ROCHESTER GAS AND ELECTRIC CORPORATION • 89 EAST AVENUE, ROCHESTER, N.Y. 14649-0001
AREA CODE 716-546-2700

SUBJECT: Revised Submittal of Quality Assurance Program for
Station Operation
R. E. Ginna Nuclear Power Plant
Docket Number 50-244

Enclosure: QA Program for Station Operation Revision 27

FIGURE 17.1.2-1
Organization Chart

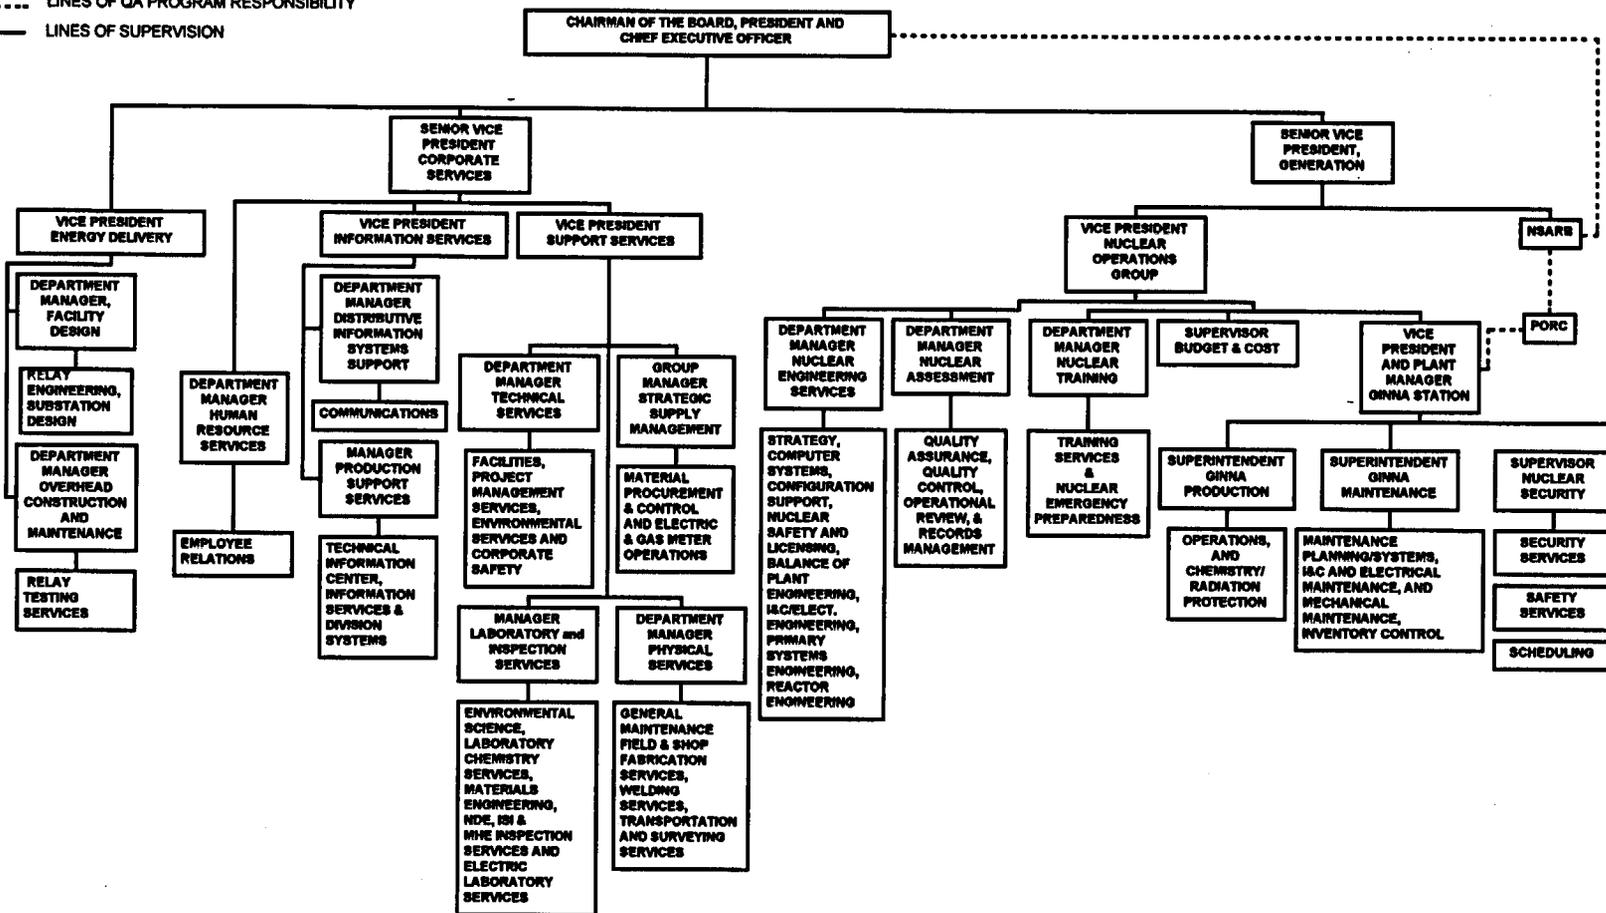
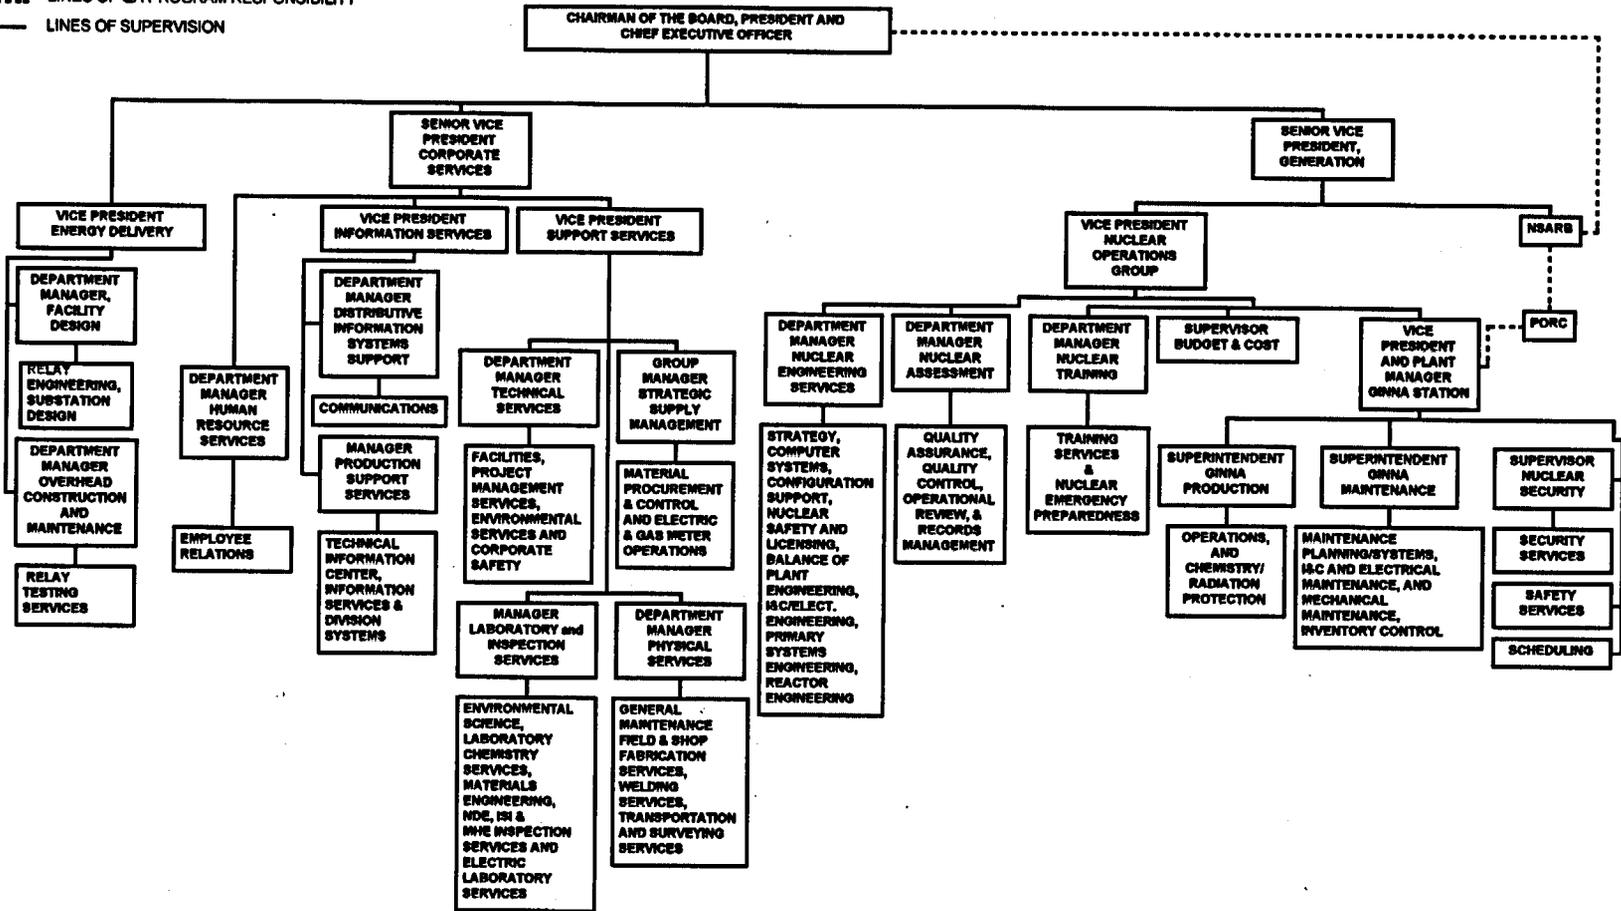
The following position titles have been changed by the corporation are reflected throughout the text of the document and on the Figure 17.1.2-1 Organization Chart:

<u>OLD</u>	<u>NEW</u>
Plant Manager, Ginna Station	Vice President and Plant Manager, Ginna Station
Group Manager, Information Services	Vice President, Information Services
Group Manager, Support Services	Vice President, Support Services
Group Manager, Energy Delivery	Vice President, Energy Delivery

Additionally, several editorial changes were made to the Figure 17.1.2-1 Organization Chart to reflect changes to positions not discussed in Section 17.1.2 Organization.
